**SUBJECT:** A report and recommendation on a proposed zone change from Commercial Community – Mixed (CC-M) and Residential Mixed (RMX) to Planned Development (PD), including the Concept Plan and Development Program Statement, located at 115-125 W. McMillan Street and 124-142 Lyon Street in CUF.

# Proposed Zone Change from CC-M and RMX to PD in CUF

Gateway Lofts, McMillan & Moerlein - Prepared for: Hallmark Campus Communities

Planned District (PD)  
Concept Plan  
Submitted June 23, 2022

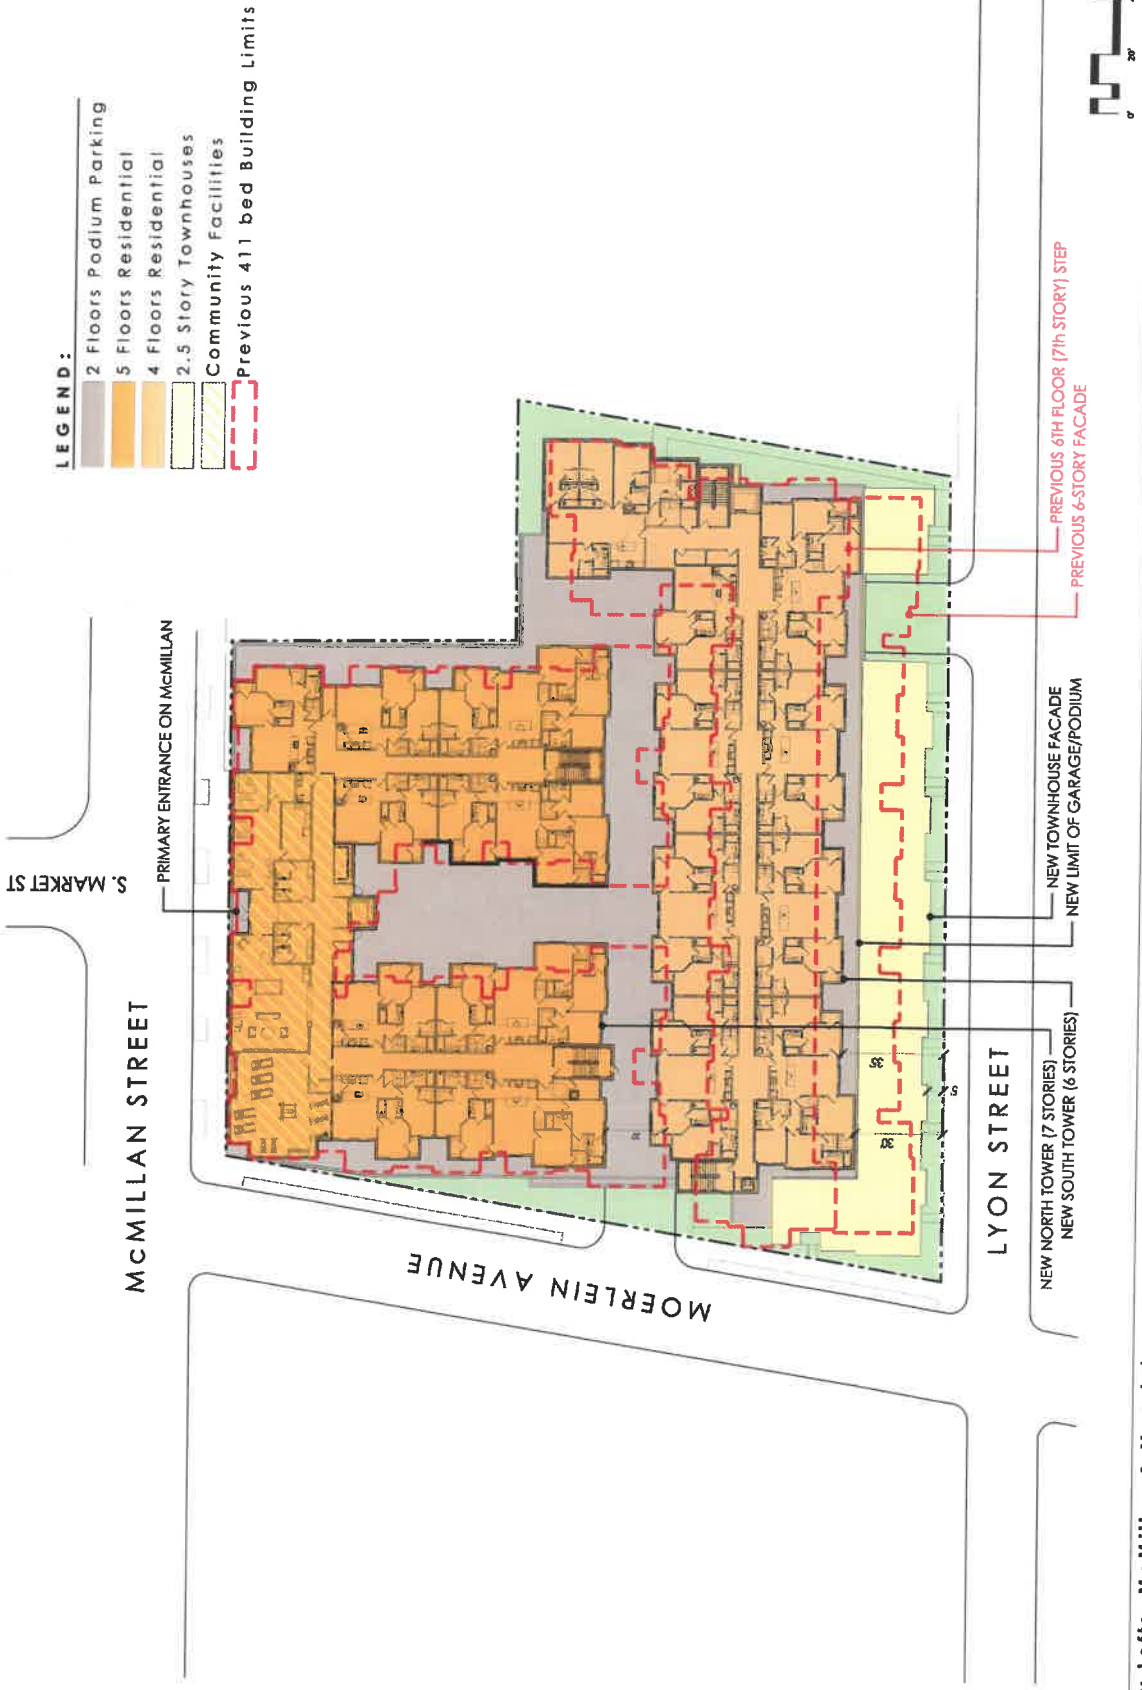
1. **ACCEPT** the Concept Plan and Development Program Statement with the following modifications:
  - a. Revise the Concept Plan and Development Program Statement to include a mixed-use component along the W. McMillan Street facade. This revision should include a list of permitted uses and the maximum square footage; and
2. **ADOPT** the Department of City Planning Findings as detailed on page 9 of this report; and

Conceptual Rendering - McMillan Facade (Day)

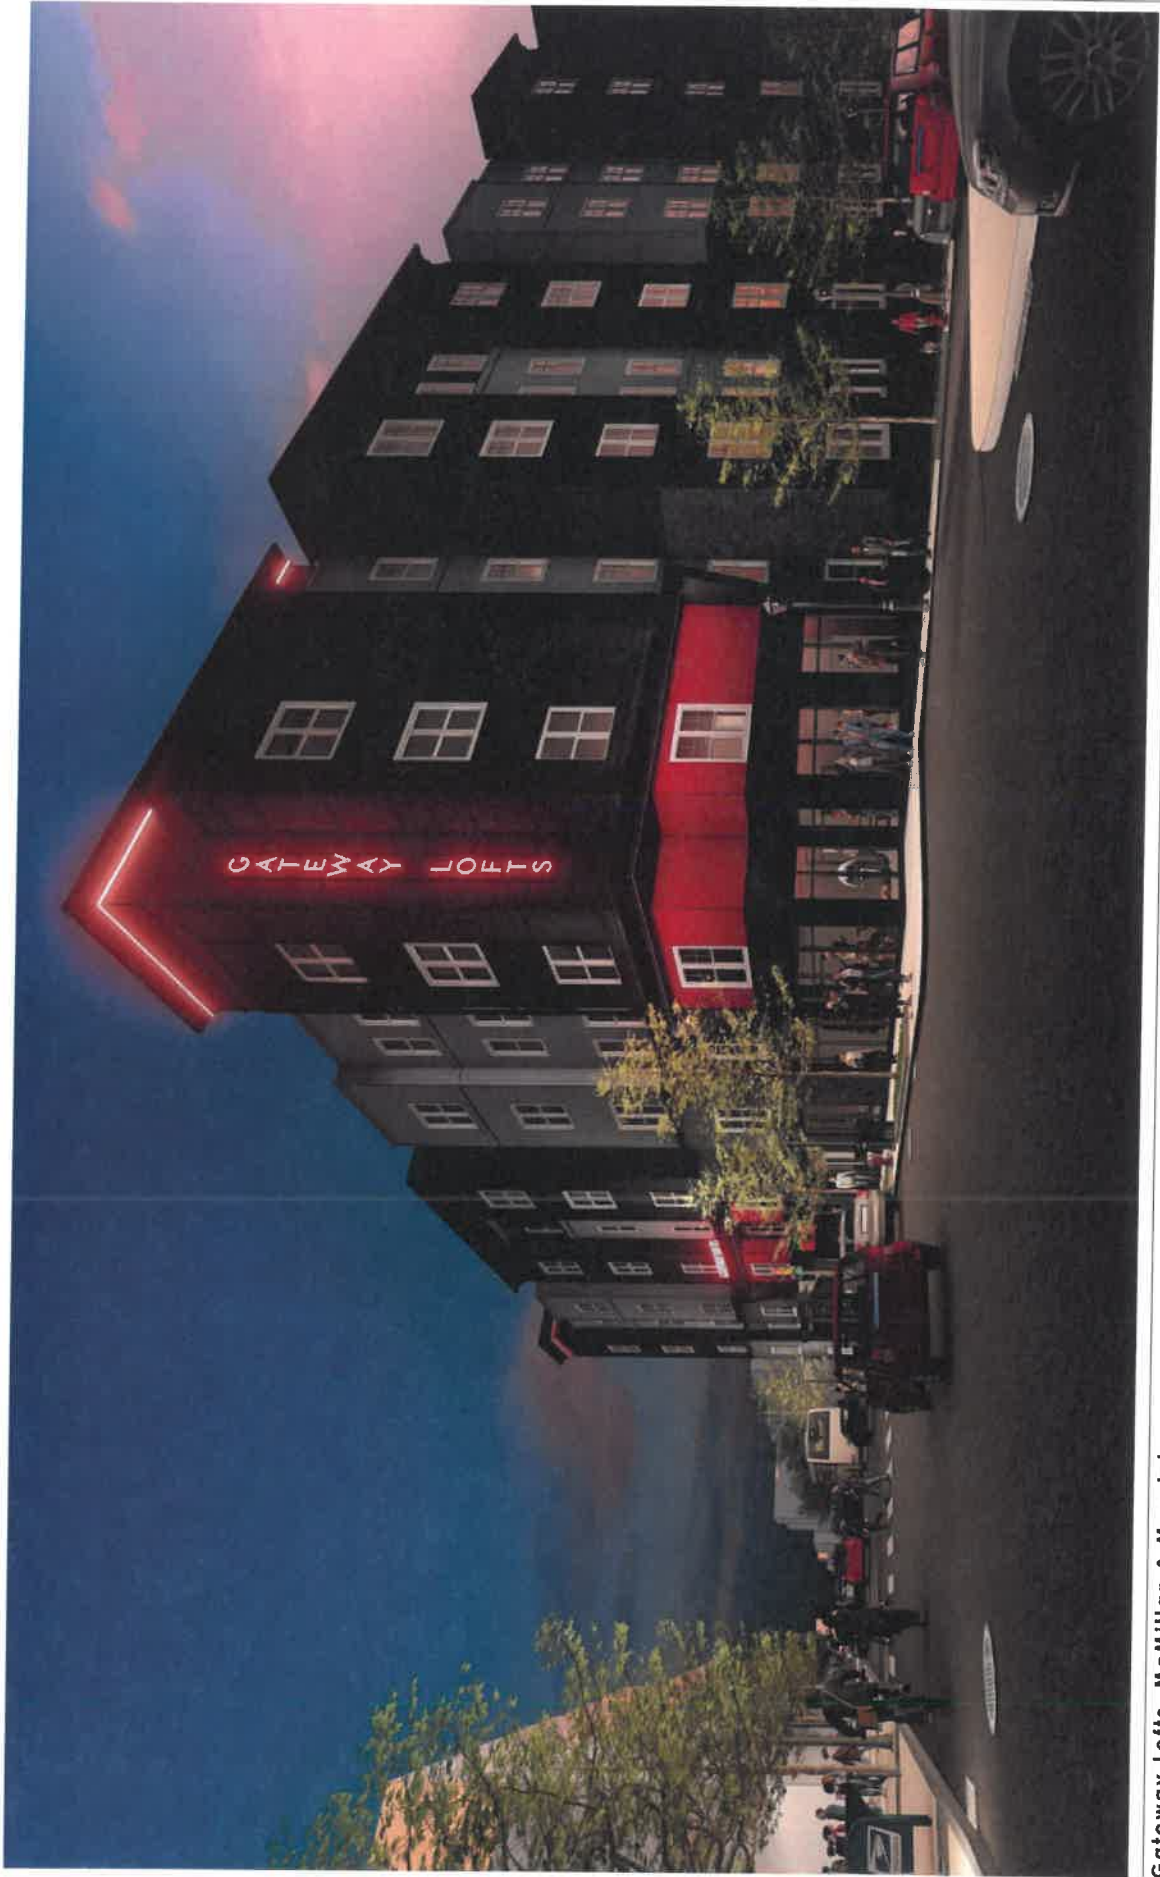
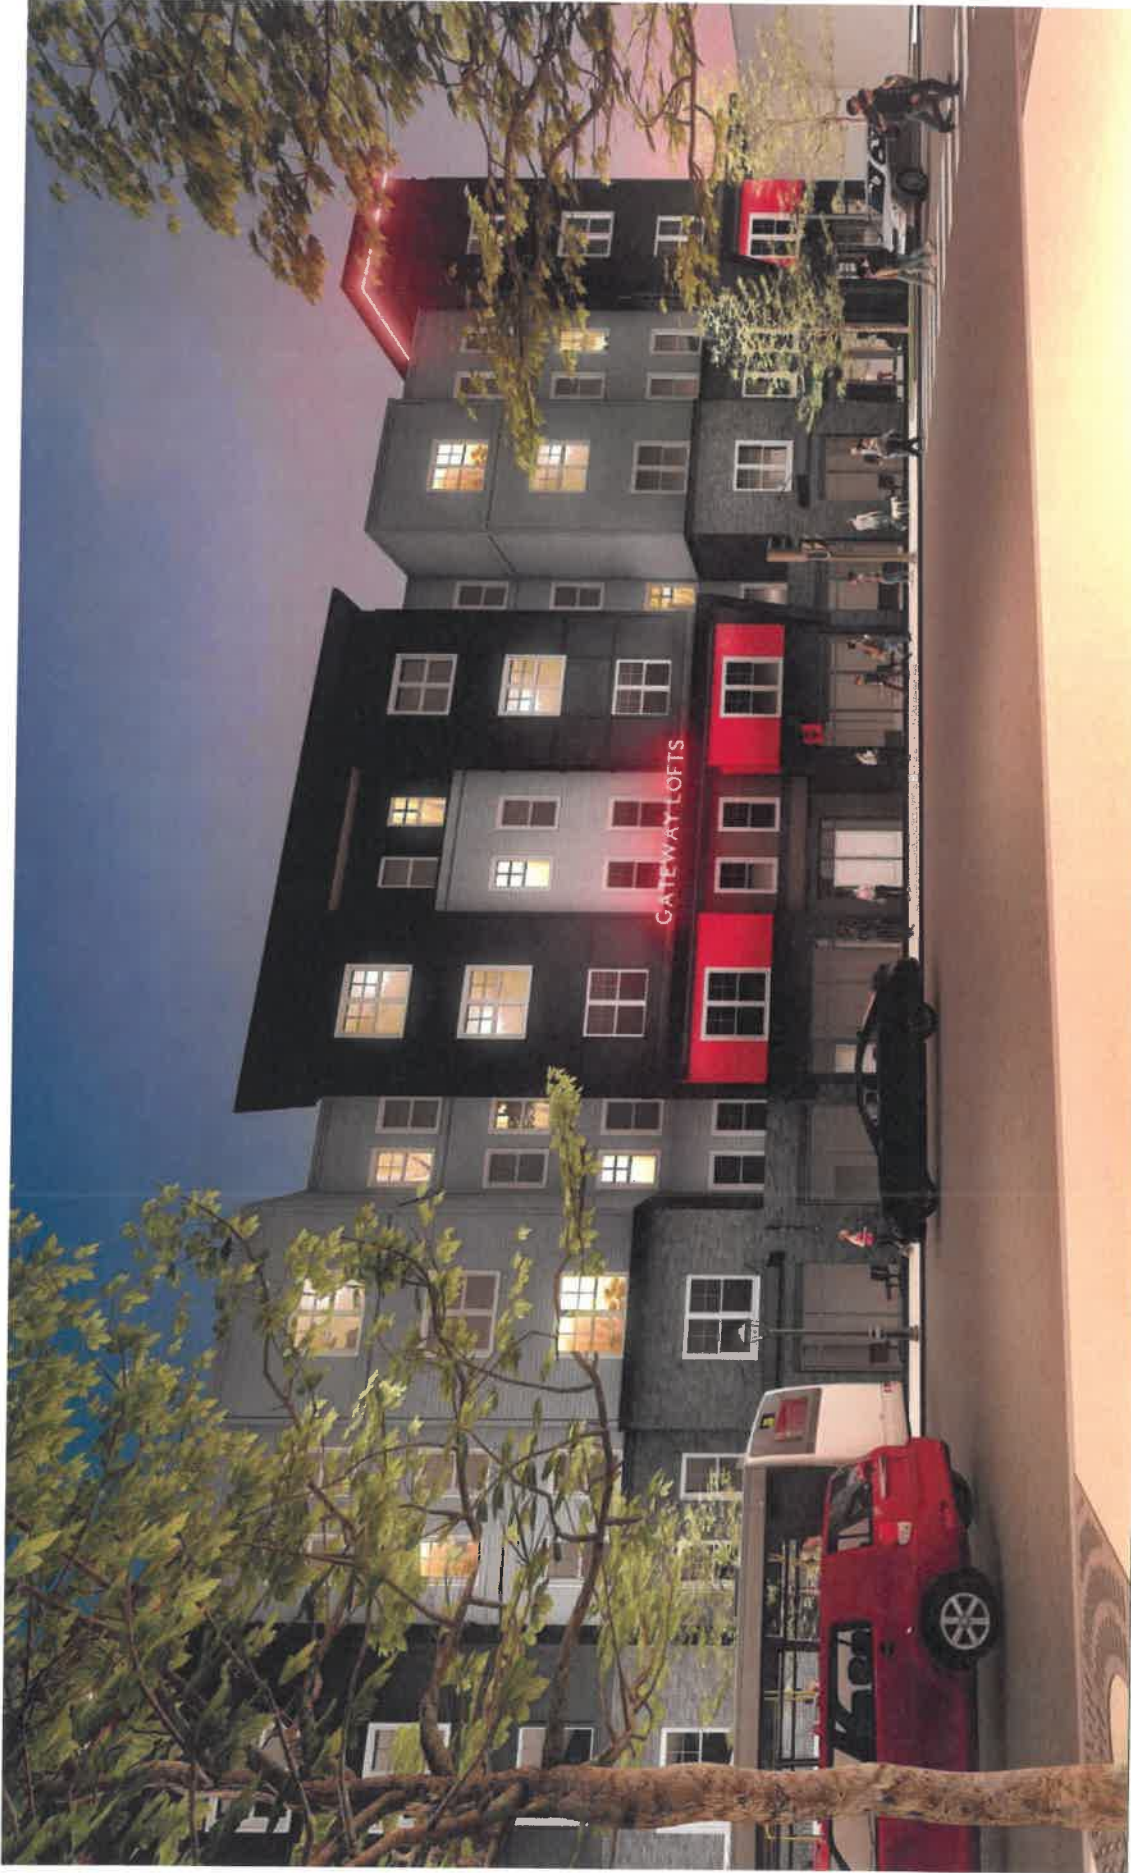
on the first floor of the building facing W. McMillan Street. Ideally the ground floor would engage the public on the north side as it was revised to do on the south side along Lyon Street.

Many in the community would prefer that the first floor along McMillan contain a retail component or other smaller scale public uses to enhance this important mixed commercial corridor in the heart of our business district. We are pleased that the developer has made efforts to activate that first-floor space with a workout room, lounge, office, etc., but we ask that the construction of the "storefront" be such that, if warranted and desired in the future, modifications could be made to accommodate one or more new entrances to new commercial space by ensuring that the interior floor grade align with the public sidewalk, etc.
